Beach Nuclear Plant
TEMPORARY CHANGE REVIEW AND APPROVAL

Doc Number OP 4F Current Rev 1 Unit PBI Temp Change No. 2004-0471
Document Title Reactor Coolant System Reduced Inventory Requirements and Nozzle Dam Operational Requirements Unit 1
Existing Effective Temporary Changes n/a
Description See PBF-0026c
(If necessary, continue description of changes on PBF-0026c and attach)

Doc Number OP 4F Revision 1 Unit PBI
 Title Reactor Coolant System Reduced Inventory Requirements and Nozzle Dam Operational Requirements Unit 1
 Temporary Change Number 2004-0471

REACTOR COOLANT SYSTEM
REDUCED INVENTORY
REQUIREMENTS AND NOZZLE DAM
OPERATIONAL REQUIREMENTS
UNIT 1

Figure 1
Reactor Coolant System Reduced Inventory Requirements

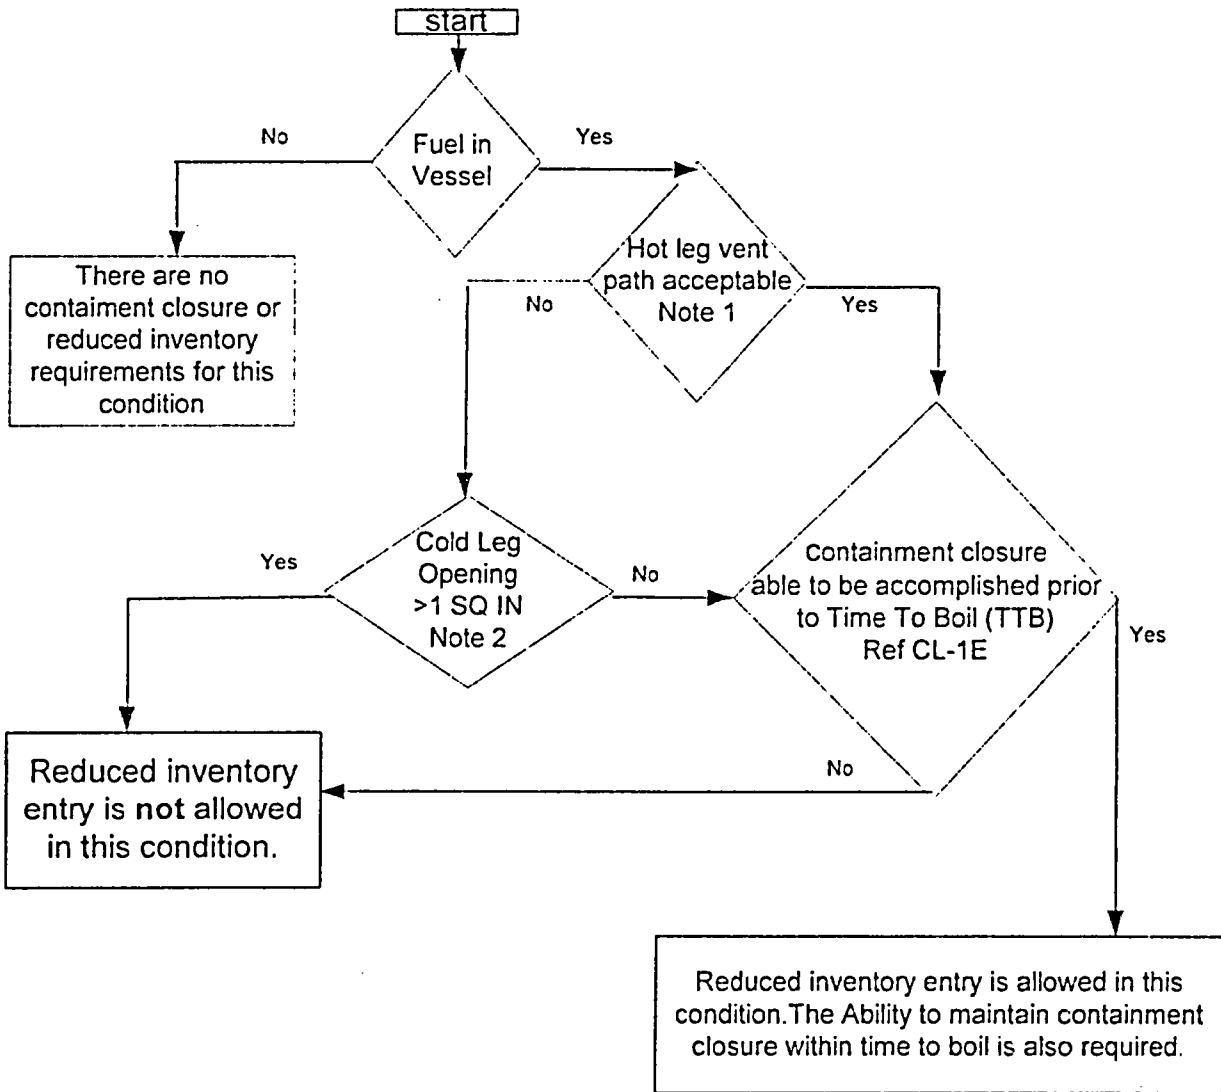
Figure 1	<ol style="list-style-type: none"> 1. Added informational note stating that figure 1 is not appropriate for nozzle dams requirements. CAP 056605 Feedback from Operator JITT (Just in Time Training) requested that this be addressed in procedure. Nozzle dam usage requires a hot leg vent path and these requirements are delineated in P&L 3.19 Nozzle Dams. Prescreened to Criteria 1 Editorial Change 2. Added Figure 1 title to 2 nd page of figure 1. Prescreened to Criteria 1 Editorial Change 3. Revised figure to include entry point and arrows for movement through diagram. 4. Added more information on containment closure requirements to allow entry into reduced inventory. Prescreen to criteria 6.
Attachment A, Attachment B	Revised note. Note was aligned with exact verbiage of NP 10.3.6. Prescreen to criteria 4.
Attachment D	Created new attachment D. Shiftly Reduced Inventory Checks. This attachment incorporates required checks to maintain required conditions necessary for reduced inventory. Prescreen to criteria 6.

Figure 1 was enhanced to better describe flow paths to allow reduced inventory conditions. This enhancement included better descriptions of containment closure and a start box.

NOTE: Not applicable for nozzle dam requirements see appropriate sections for requirements.
